# **Shell Proposed Jack Mine Expansion and Pierre River Mine Projects**

## **Environmental Impact Assessment and Application Review**

**Prepared for:  
Fort McKay Industry Relations Corporation**

February 2010

**Figure 9-1: Distribution of Vegetation Cover Class at Baseline and Closure**

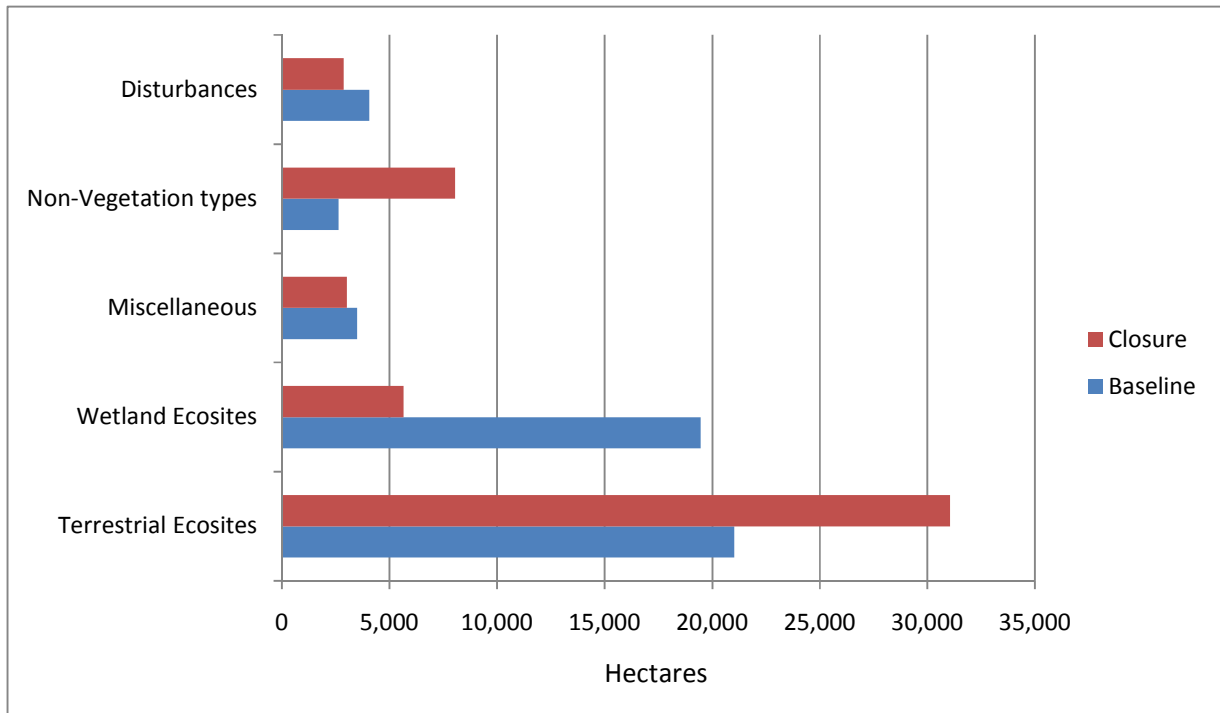
Following mining and reclamation there will be a net increase in upland ecosite area and a significant loss of wetland area within the LSA (Table 9-1; Figure 9-1). The total area of wetlands will decrease by 13,814 ha to about 5,653 ha (or 71% less than baseline conditions) while the area of terrestrial uplands will increase by 10,032 ha. Following closure, terrestrial uplands will occupy 31,056 ha, or about 61% of the reclaimed area. There will be a substantial change in the distribution of wetland types following reclamation; the areas covered by peat forming wetlands will decrease from 15,157 ha to 4,319 ha following closure. The area covered by non-peat forming wetlands will also decrease from 4,299 ha at baseline to about 1,335 ha after reclamation. Open water and littoral areas will increase by 5,421 ha (210%) over baseline conditions.

**Figure 12-1: Fort McKay Community Assessment – Pace of Development and Reclamation for Jackpine Mine Expansion**

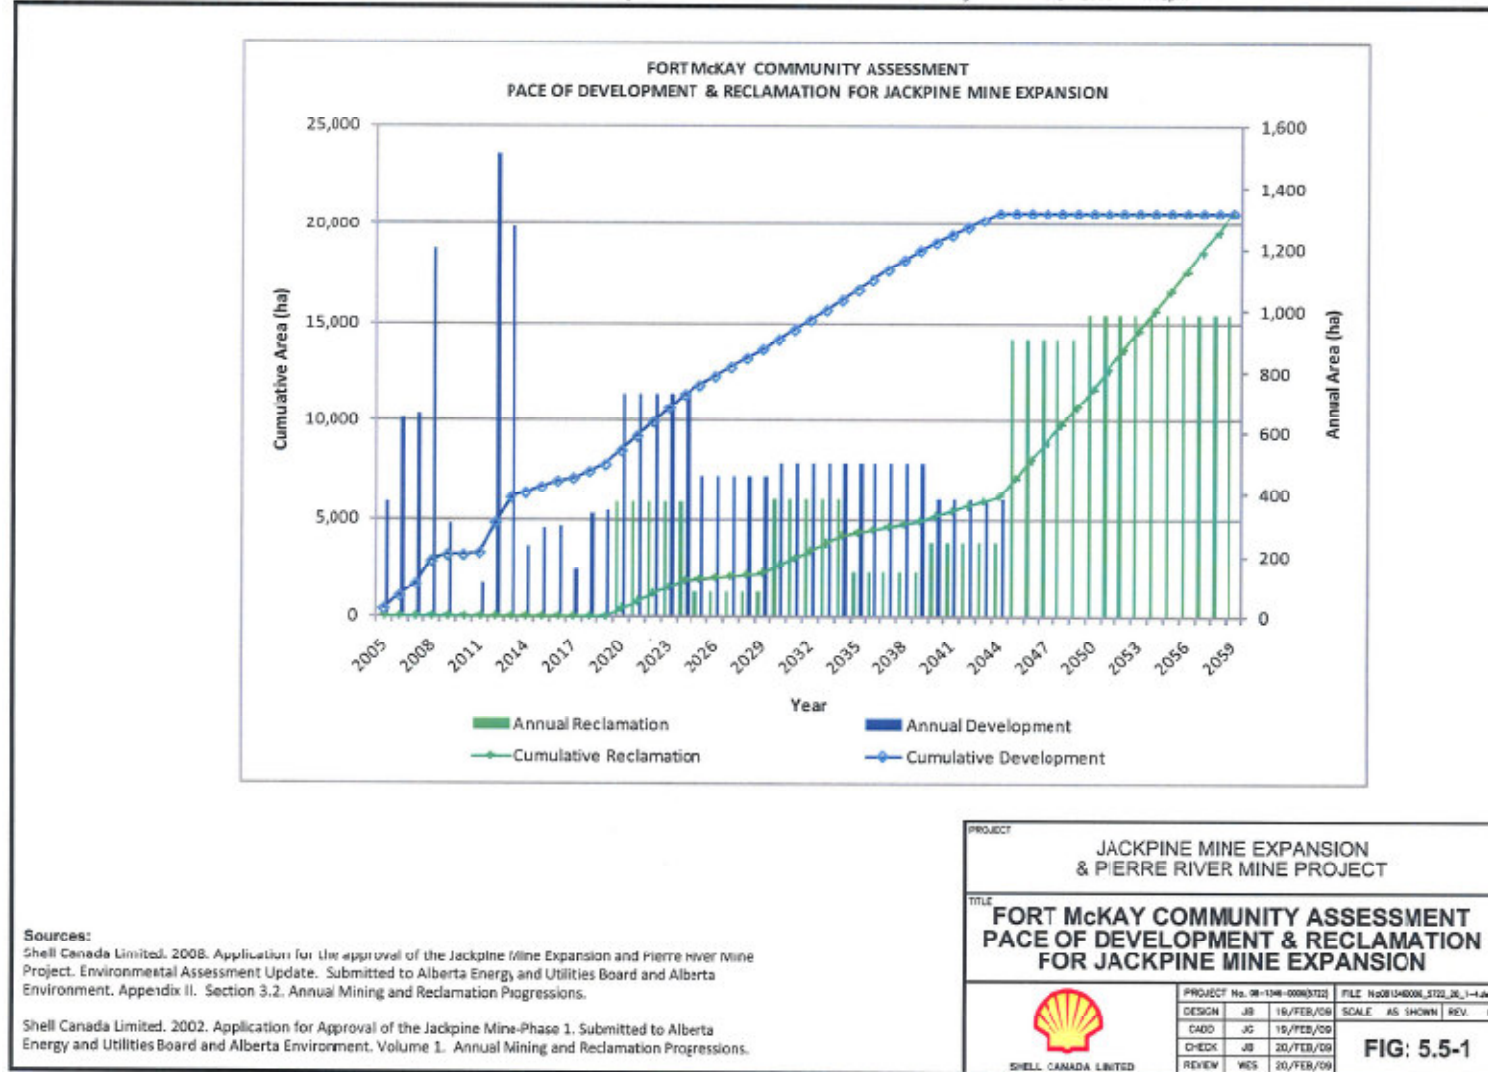
44,000 ha of land. The proposed JME will cover 20,555 hectares and the proposed PRM a further 10,403 ha (see EIA Update, May 2008). The JME will not be fully reclaimed until 2060 (see Figure 12-1 in the C&R review). The PRM as proposed will not be fully reclaimed until 2050.

The existing approved Shell mines (Muskeg River and Jackpine) and the proposed large scale mine developments will ultimately occupy a total of 44,000 ha of land. The proposed Jackpine Mine Expansion will cover 20,555 ha and the proposed Pierre River a further 10,403 ha. The Jackpine Mine (Figure 12-1) will not be fully reclaimed until 2060, with the likelihood that a further 10 to 20 years will be needed before the land can be certified as reclaimed, which means that the land covered by this mine expansion will be alienated from two to three generations of Fort McKay people. The Pierre River Mine as proposed will not be fully reclaimed until 2050. A further 15 to 20 years of vegetation establishment will likely be required before this land will be certified by government as reclaimed.

**Figure 12-2: Fort McKay Community Assessment – Pace of Development and Reclamation for Pierre River Mine Expansion**

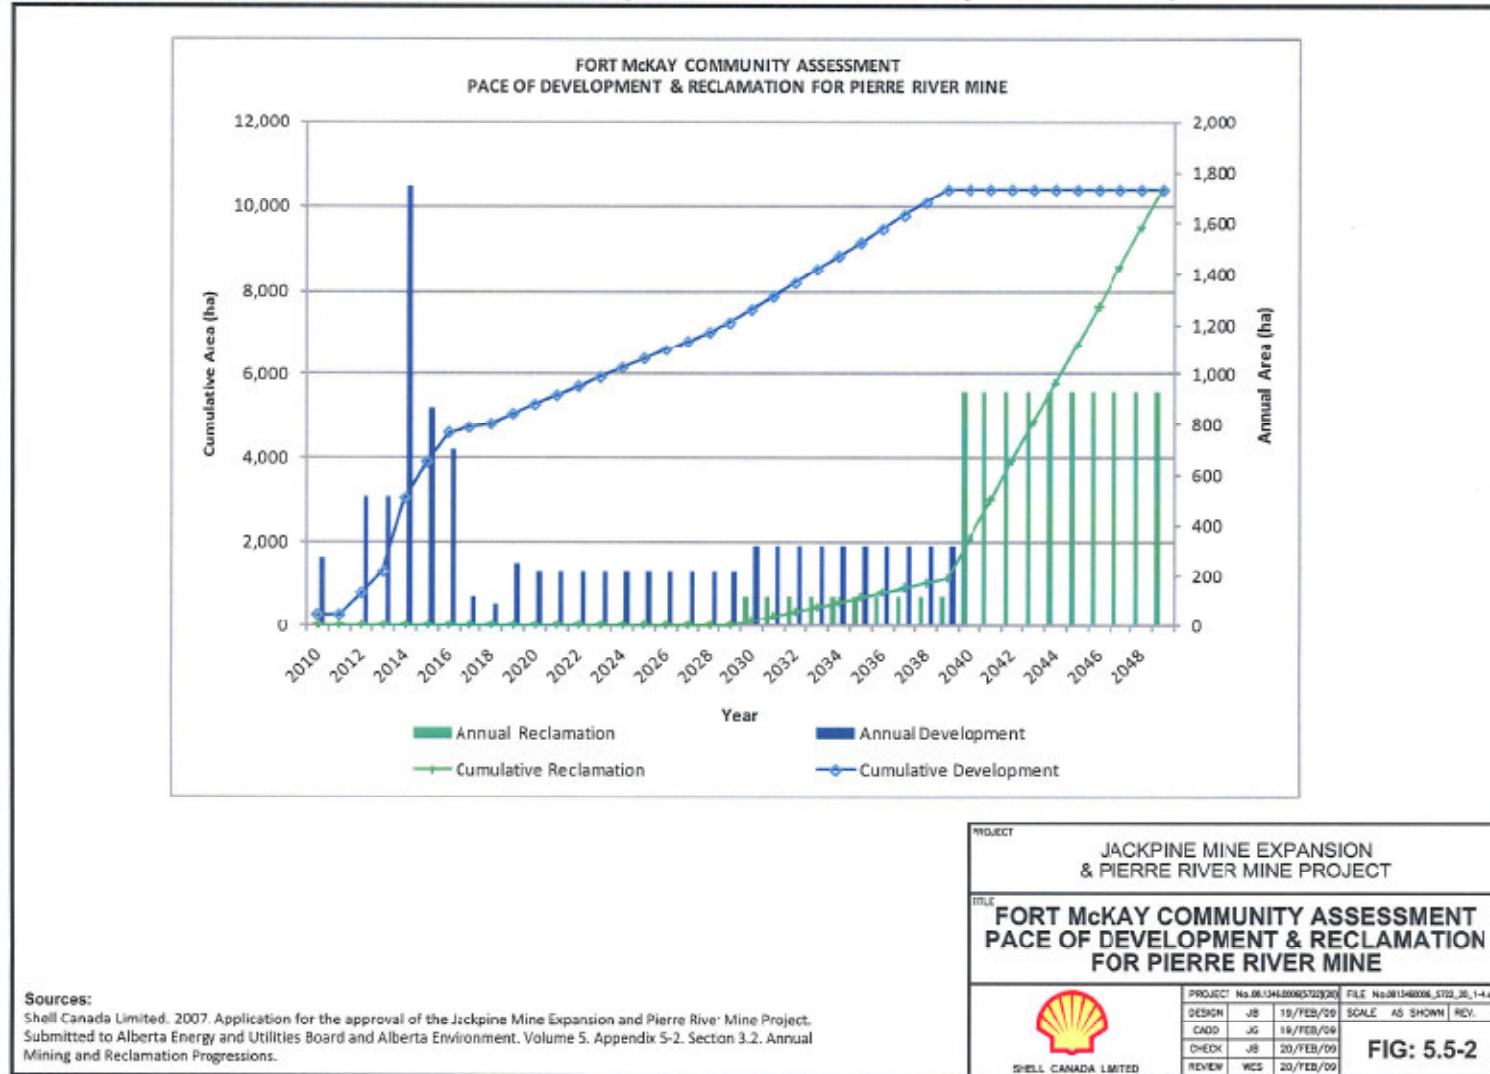
The proposed pace of reclamation is different between the Jackpine Expansion and Pierre River mines. At Pierre River Mine, land is disturbed during the first 30 years of mining (approximately one half of the area is disturbed within the first 10 years) but very little reclamation (less than 10%) is completed during mining (Figure 12-2). Reclamation is primarily undertaken during the 10-year period after mining is completed in 2040.

**Figure 12-3: Fort McKay Community Assessment – Pace of Development and Reclamation for Muskeg River Mine**

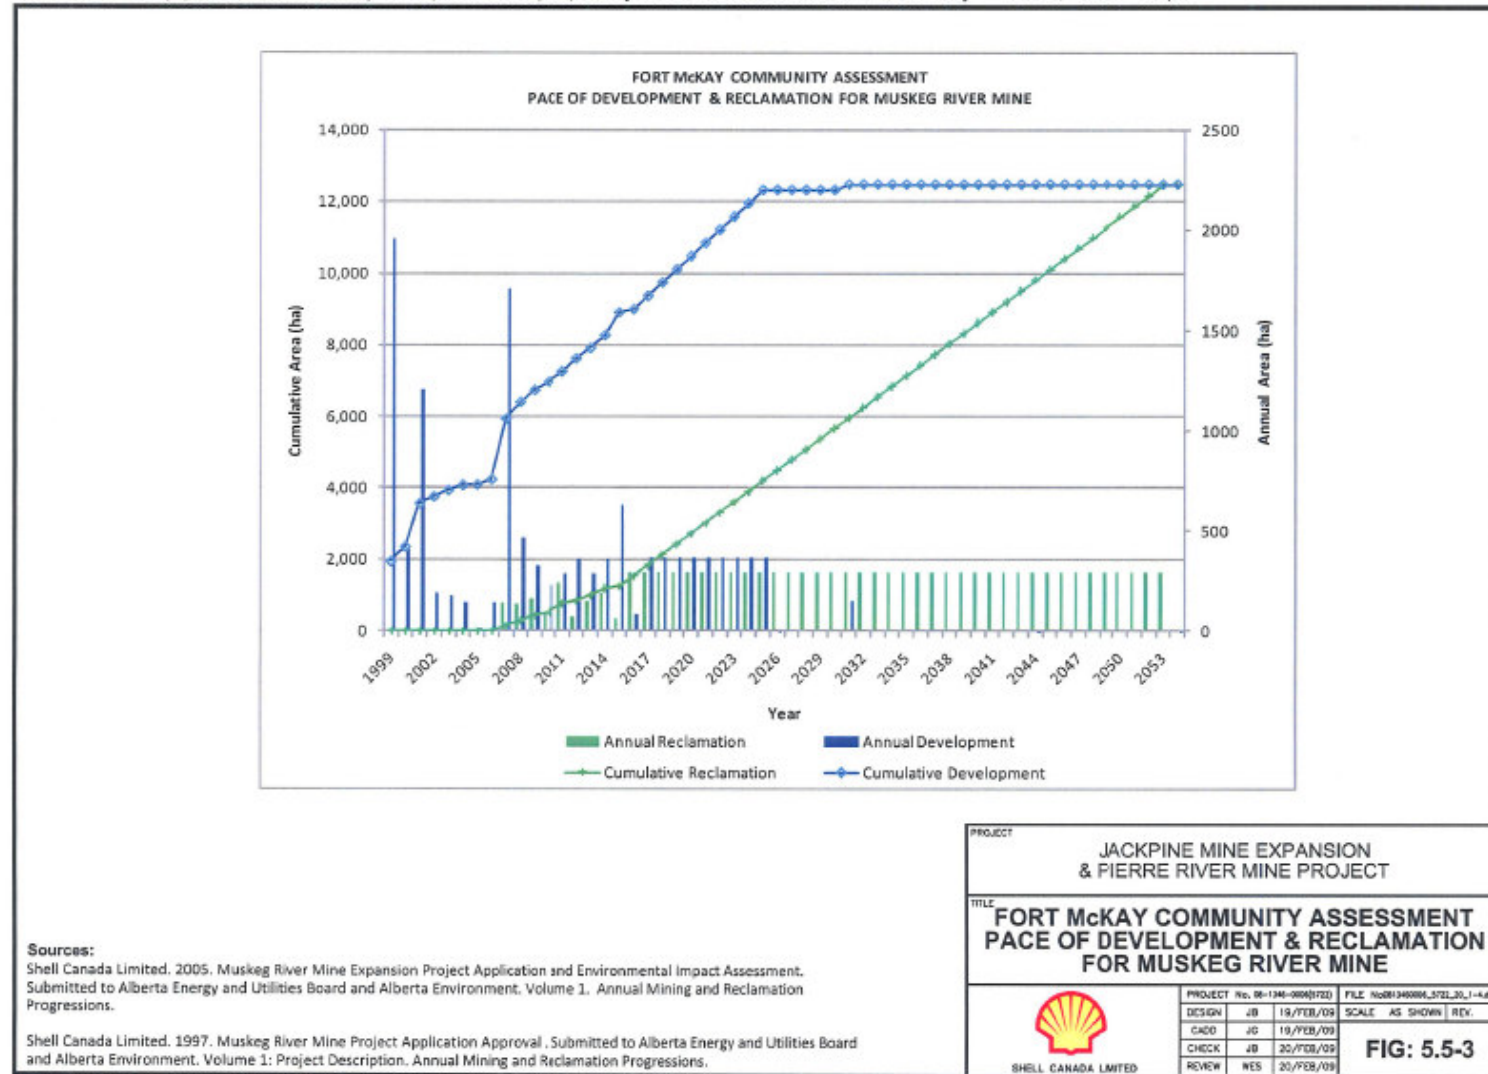
In contrast, at the proposed Jackpine Mine Expansion, the disturbance occurs over a longer time frame, approximately 40 years, and during that time period approximately 25 percent of the area is reclaimed. The remaining 75 percent of the area is then reclaimed over the next 20 year period after new mine disturbance has ceased (Figure 12-1). While this later scenario reclaims a higher percentage of land earlier in the mining process than the Pierre River scenario, reclamation at both of these projects occurs at a much slower pace than at the Muskeg River Mine where, after 2017, land reclaimed in each year keeps pace with new land disturbance (Figure 12-3).

**Figure 12-4: Fort McKay Community Assessment – Pace of Development and Reclamation for Jackpine Mine, Pierre River Mine and Muskeg River Mine**

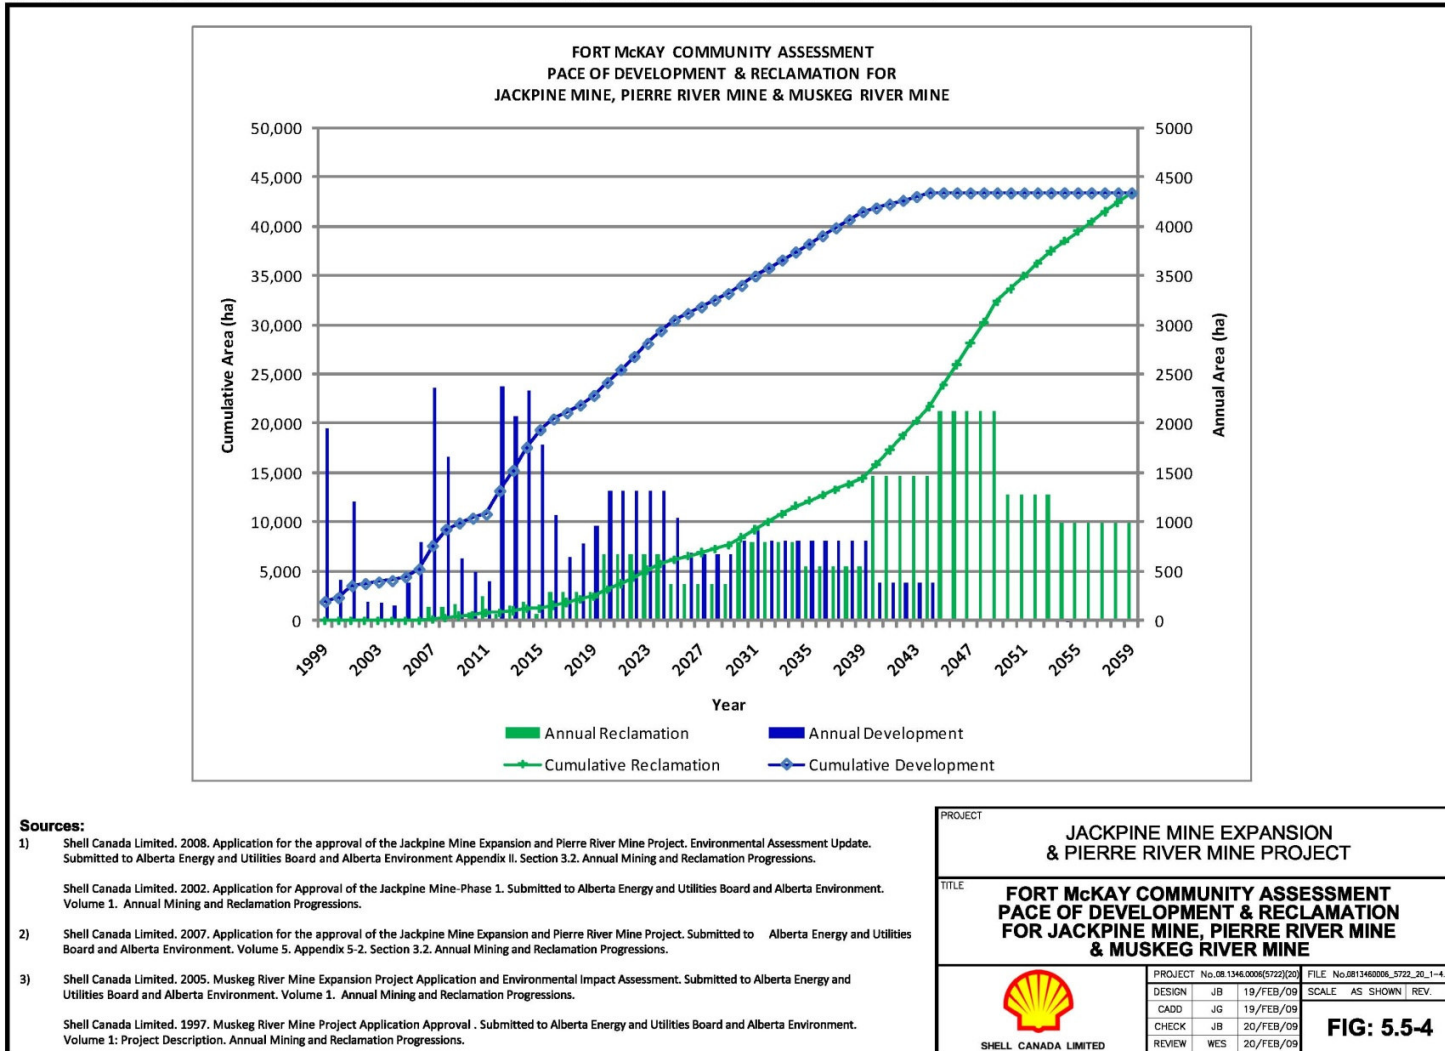
When the disturbance and reclamation from all three mines are considered together, it will take 45 years of mine operation before 50% of the disturbed land will be reclaimed, and the final 50% will be reclaimed during the last 15 years (Figure 12-4).

The annual reclamation shown in Figure 12-1 to Figure 12-4 represents the date the land is proposed to be revegetated but some of the reclamation may not be successful and may require additional treatment. Even if the initial revegetation is successful it will often take an additional 20 to 25 years before these sites begin to mature into forests and 120 years before they would be considered old growth forests. It remains completely unknown as to how long it could take to create a functioning organic wetland on the reclaimed landscape as this has not been done in the oil sands to date. Even if marshes are established relatively quickly it could take hundreds or thousands of years for organic fens and bogs to develop on the reclaimed landscape, assuming they ever do develop from the marsh wetlands.
